silnik do MP100D Makita TE00000640 (TE00000478)

Technical Information

Y08765

Title	Change of Motor assembly with Air pipe assembly
Model	MP100D
Country	All countries
Description	[1][2] Air pipe assemblies for production have been unified to ø6mm thread type. [3][4] Motor assembly for production have been changed according to [1][2]. Note: There is no difference in performance between ø6mm thread type and ø8mm thread type. However, the repairs are different. See below.

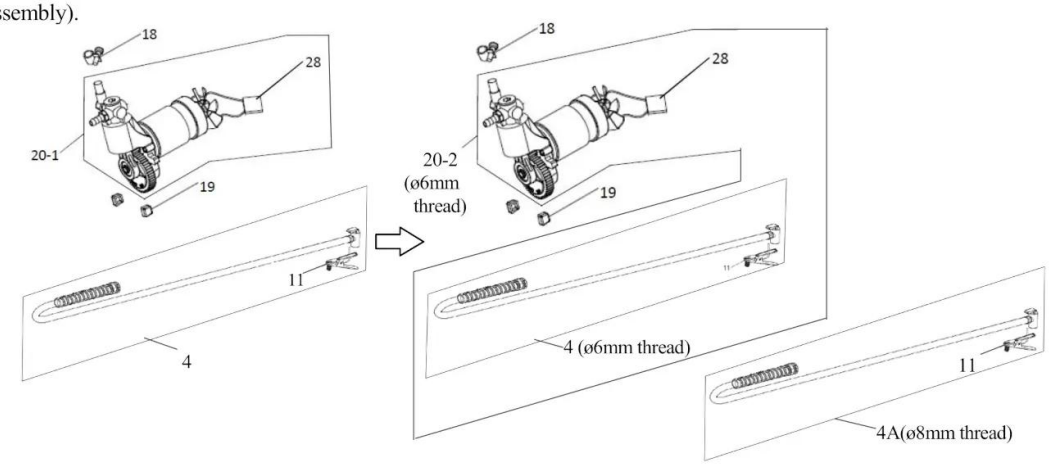
ø8mm thread ø6mm thread

Current Air pipe assembly has either ø8mm or ø6mm threaded air pipe end as shown above.

⇩

New Air pipe assembly has the only ø6m threaded air pipe end.

Current Motor assembly has either ø8mm or ø6mm thread joint portion.

⇩

New Motor assembly has the only ø6mm thread joint portion.

Only Air pipe assembly wants to be replaced;
Check the thread diameter of the machine that the customer repairs, and order the same Air pipe assembly.

Motor assembly wants to be replaced;
Because of parts unification to ø6mm thread type, order the new Motor assembly (with ø6mm thread Air pipe assembly).
